Date: 07.31.2019

To: **Ron VanZee, Township Supervisor**
Hayes Township
9195 Old US 31 North
Charlevoix, MI 49720

Project: Camp Seagull

We have completed our analysis of the “areas of concern”, and generated the following report that includes an assessment of each issue, proposed approaches to resolving the issues and an opinion of estimated construction costs for implementation.

FIGURE 8.1

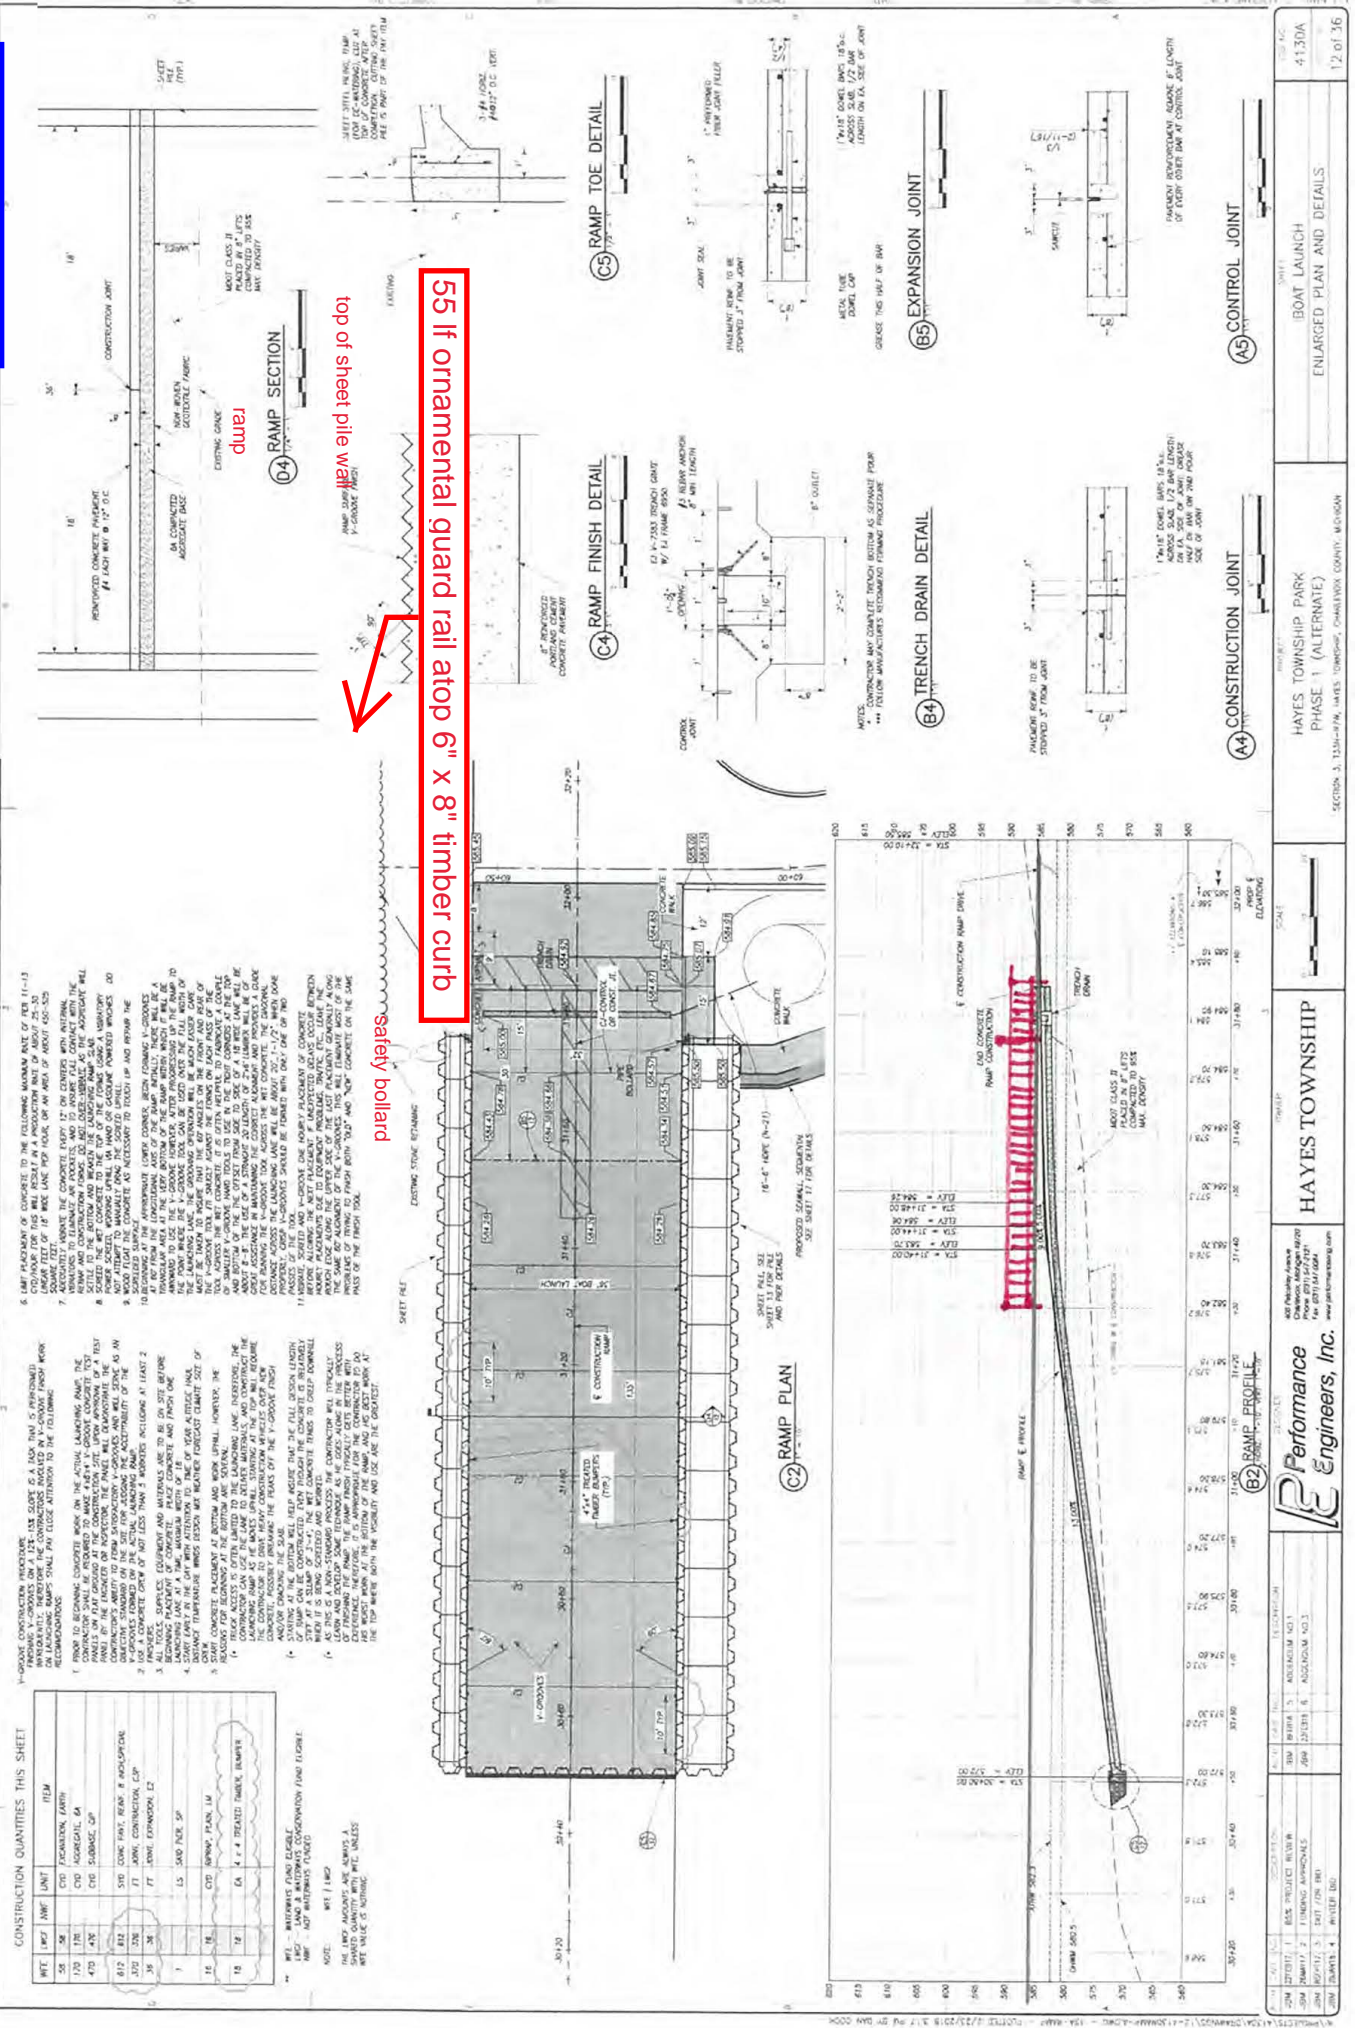
The sheet pile wall adjacent to the west edge of the boat ramp presents a hazard should people decide to walk along the top of the wall, which is held to just above the elevation at the top of the boat launch. Because the top of the wall is near pavement grade at the top of the ramp, it also presents a challenge for drivers backing into the boat ramp, because there is no clear indication nor significant barrier to notify the driver of the location of the top of wall and edge of ramp.

Reviewing the drawings, it appears that a double sheet-pile wall was originally proposed in this location but was eliminated.

Add a bumper to help reduce the risk of a car backing over the edge of the wall and ramp and add a guardrail to fulfill the building code requirement that pedestrians be protected from falls exceeding 18" in elevation. Surface-mount guard rail could be installed atop a 6" x 8" timber bumper, which in turn would be mounted on spacers to allow boat ramp surface drainage to pass beneath it. Include 7" x 10" "Danger – Keep Off" sign at north end of wall on guardrail signage prohibiting people from walking or climbing on the wall.

See Figure 8.1.
